LONG TERM AND OPERATIONAL SAFETY ISSUES AT THE WIPP

Lokesh Chaturvedi, Robert H. Neill, Matthew K. Silva
Dale Rucker, James K. Channell and William T. Bartlett
Environmental Evaluation Group
7007 Wyoming Boulevard NE, Suite F-2
Albuquerque, NM 87109

ABSTRACT

Figure 3. Pressurized brine encounters in the Castile Formation in the vicinity of the WIPP site

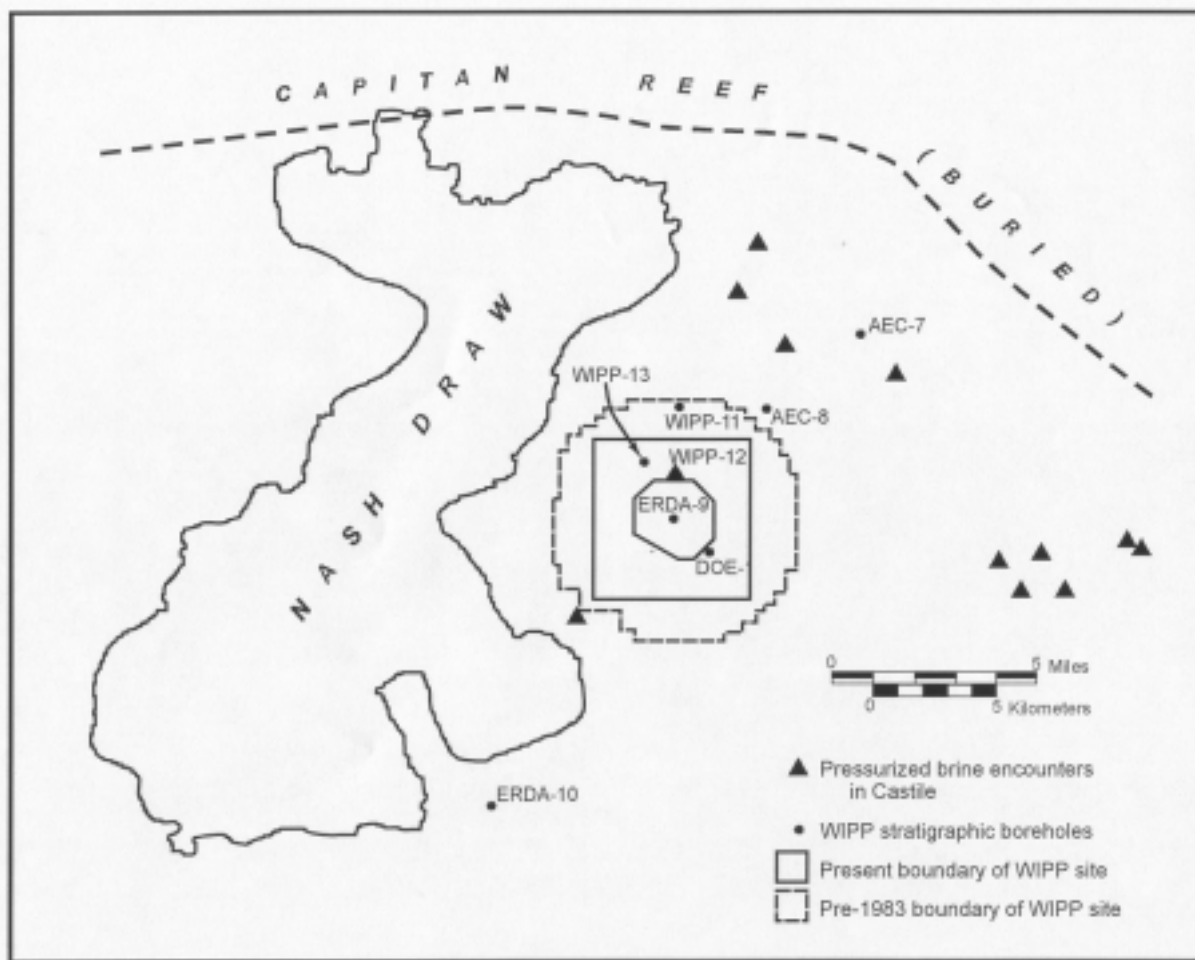
The EEG raised a number of issues related to the Castile Formation brine reservoirs in commenting on the CCA. The EPA has accepted all of the EEG suggestions except the one related to the assumption of the probability of encounter of brine reservoirs. The CCA assumed 8% probability on the basis of faulty assumptions, as noted by EPA. The EEG recommended 100% probability on the basis that the WIPP-12 brine reservoir (Fig. 3) was large enough to most likely extend under the repository. The EPA has sampled on a range of 1 to 60%. The time-domain electro-magnetic (TDEM) survey data may be interpreted to indicate that the brine exists only under 60% of the repository. Also, some boreholes adjacent to the brine producing boreholes are known to be dry. For these reasons, it appears more reasonable to assume a fixed 60% probability of encounter of pressurized brine in the Castile Formation.
